UNITED STATES
 NUCLEAR REGULATORY COMMISSION
 REGION II
 101 MARIETTA ST., N.W., SUITE 3100
 ATLANTA, GEORGIA 30303

Report Nos. 50-250/80-17 and 50-251/80-15

Facility Name: Turkey Point Units 3 and 4

SUMMARY

Fig. 2 TURKEY POINT HEALTH PHYSICS DEPARTMENT ORGANIZATION CHART

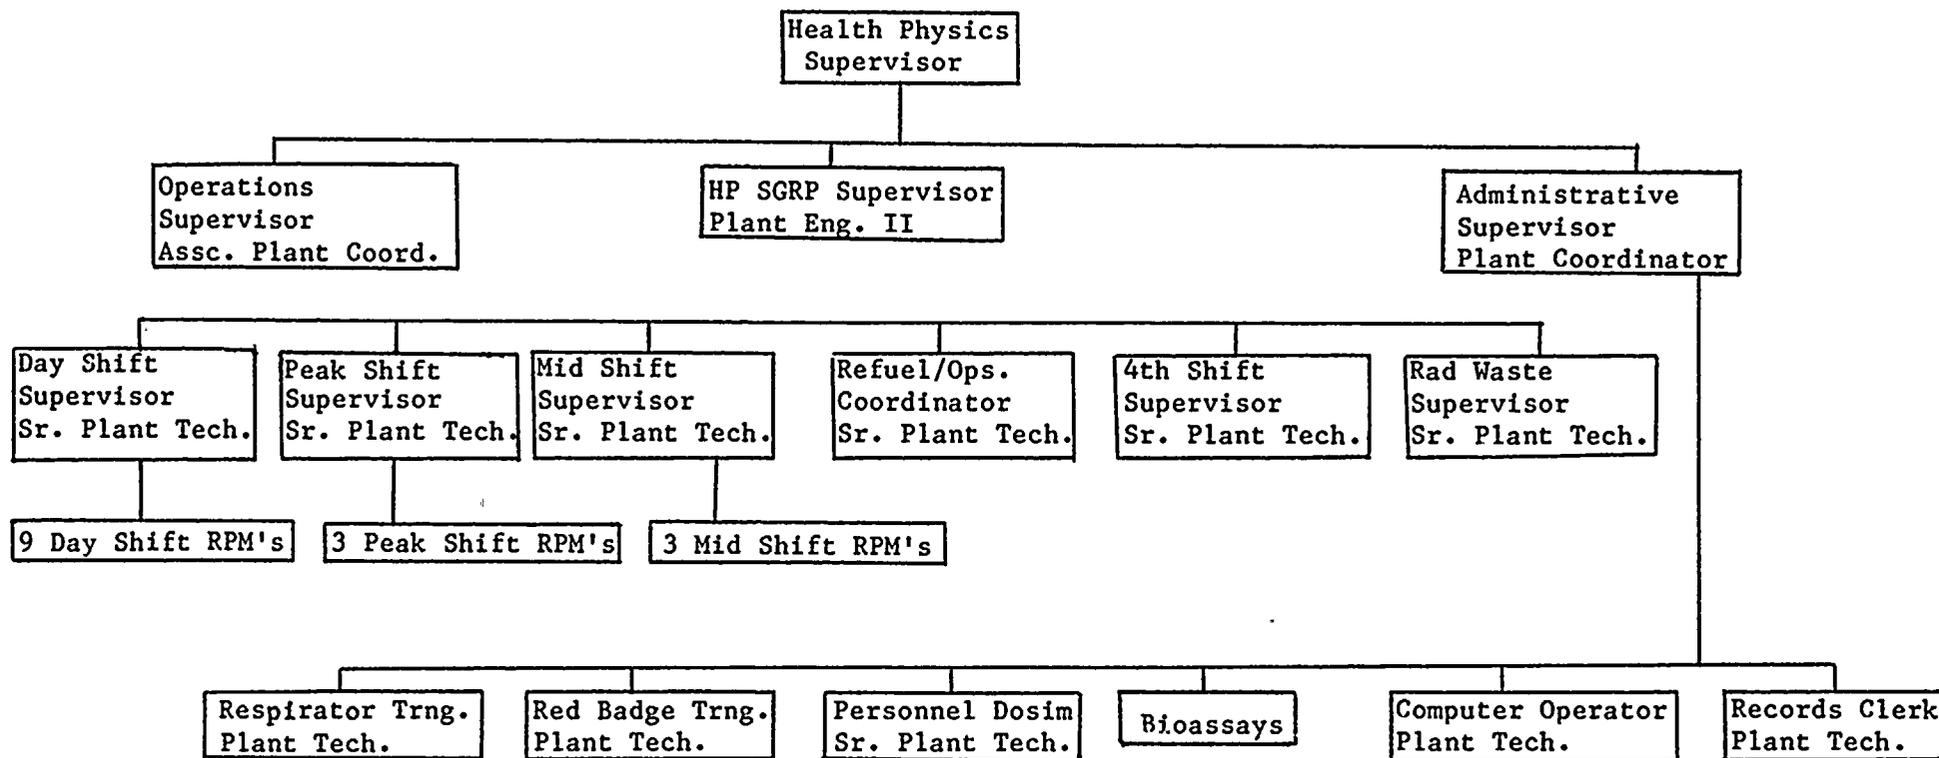
- b. The organization of the health physics department is shown in Figure 2. The entire department presently consists of 32 permanent employees. The health physics operations supervisor's responsibilities is to ensure that the day-to-day operations in the plant are adequately covered. He is also responsible for ensuring that required surveys are taken, instruments are calibrated, and respirators are cleaned and repaired. In addition to all the health physics shift supervisors, a radwaste supervisor reports directly to the operations health physics supervisor. In part, the present function of the radwaste supervisor, is to ensure that solid waste shipments are made in accordance with regulations. The direct responsibility for liquid and gaseous radioactive wastes lies in the chemistry department. The health physics administrative supervisor is responsible for ensuring that all required records are maintained, that dosimetry records are reviewed and adequate, that respirator and employee training are administered and adequate. In addition, he is responsible for the development of computer programs, which aid the department in gathering, distributing and evaluating raw data necessary for efficient routine daily operations. The staffing and delegation of authority within the health physics department appeared adequate except as detailed below.

- c. The inspectors noted that there was no formal structure within the health physics organization which had overall responsibility for ALARA (i.e., maintaining plant personnel radiation exposures as low as reasonably achievable). From discussions with the plant manager, the health physics staff and other plant personnel, and through direct observation, the inspectors concluded that many elements of an ALARA
